LYMAN MOORE SCHOOL
At
NORTH DEERING
For The
CITY OF PORTLAND, MAINE.

175 Auburn Street - Proposed addition
to Lyman Moore School.

Examination of preliminary plans for the proposed addition to the Lyman Moore School in relation to Zoning Ordinance and Building Code requirements discloses the following questions as to compliance therewith:

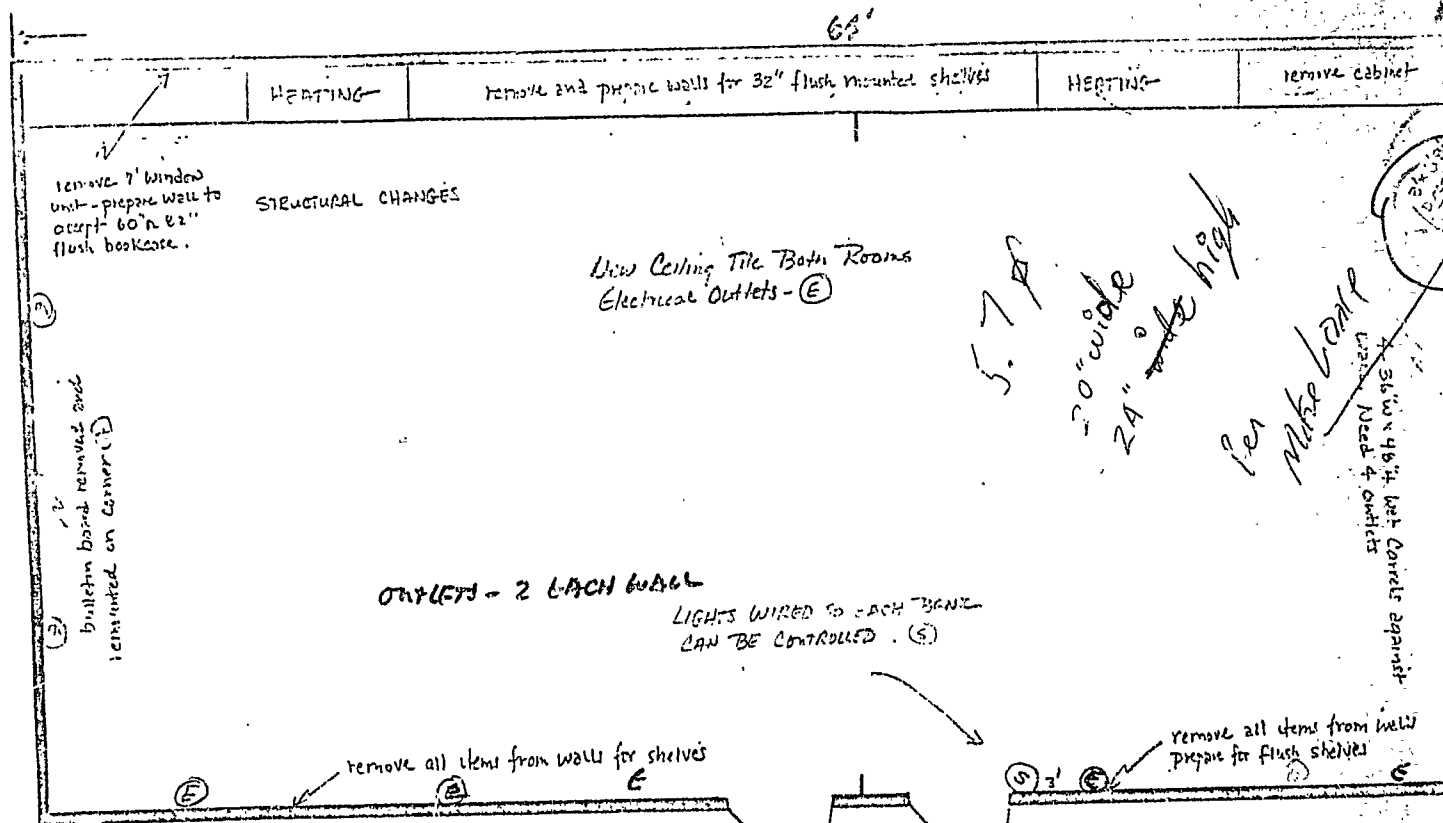
Be advised that 20" x 24" does not provide 5.7 sq. ft.

Be advised that 20" x 24" does not provide 5.7 sq. ft.

remove 7' window unit - prepare wall to accept 60" x 22" flush bookcase.
